UNITED STATES PATENT AND TRADEMARK OFFICE

APPLICATION NO.	FILING DATE	FIRST NAMED INVENTOR	ATTORNEY DOCKET NO.	CONFIRMATION NO.
10/685,112	10/14/2003	Erno Temesi	21334-1267	4430
29450	7590	04/10/2007	EXAMINER	
BARLEY SNYDER, LLC			VU, BAO Q	
1000 WESTLAKES DRIVE, SUITE 275			ART UNIT	
BERWYN, PA 19312			PAPER NUMBER	
			2838

Office Action Summary	Application No.	Applicant(s)	
	10/685,112	TEMESI ET AL.	
	Examiner	Art Unit	
	Bao Q. Vu	2838

DETAILED ACTION

FIG. 8

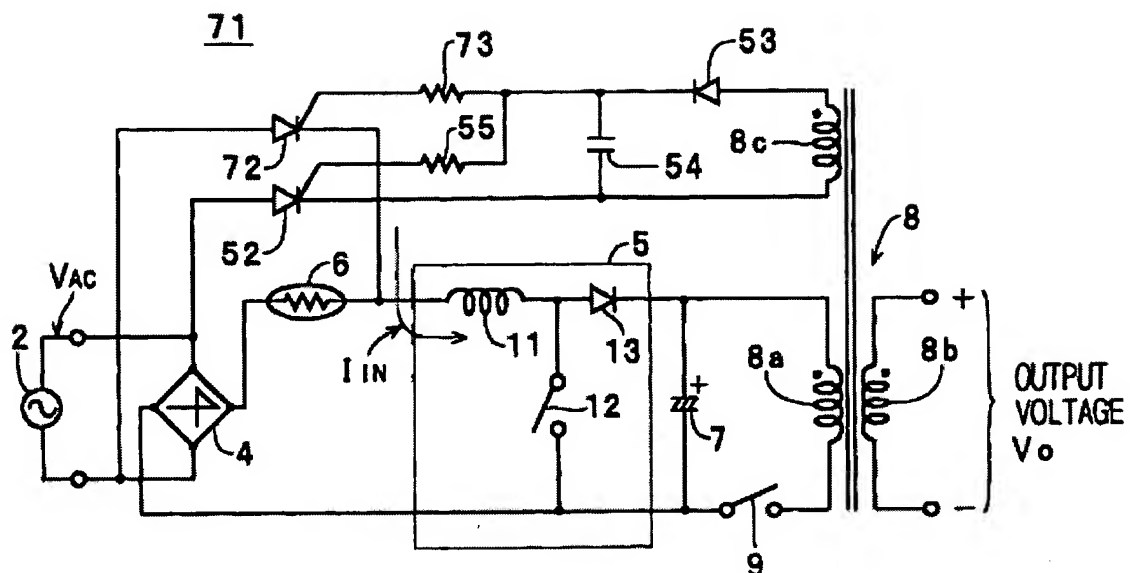
2. Claims 1, 3, 7, 8-11, 13, 15, and 18-21 are rejected under 35 U.S.C. 103(a) as being unpatentable over Matsumoto et al. (USP 6,285,170) in view of Gordon (USP 5,815,386). Matsumoto discloses the claimed, a bridge rectifier (4), feedback windings (8c), a rectifier switches (52 and 72) and a current limiting circuit (6), with the rectifier switch (52 and 72), except for having the feedback inductor inductively coupled to the input inductor of the boost converter. Gordon discloses that it is known in the art to provide the feedback inductor inductively coupled to the input inductor of the boost converter. It would have been obvious to one having ordinary skill in the art at the time the invention was made to provide the switching power supply circuit of Matsumoto with the feedback inductor inductively coupled to the input inductor of the boost converter of Gordon, in order to make for a more efficient circuit. Per claim 20, see figure 7 in which the controlled rectifying element is in parallel with the resistor for current limiting.
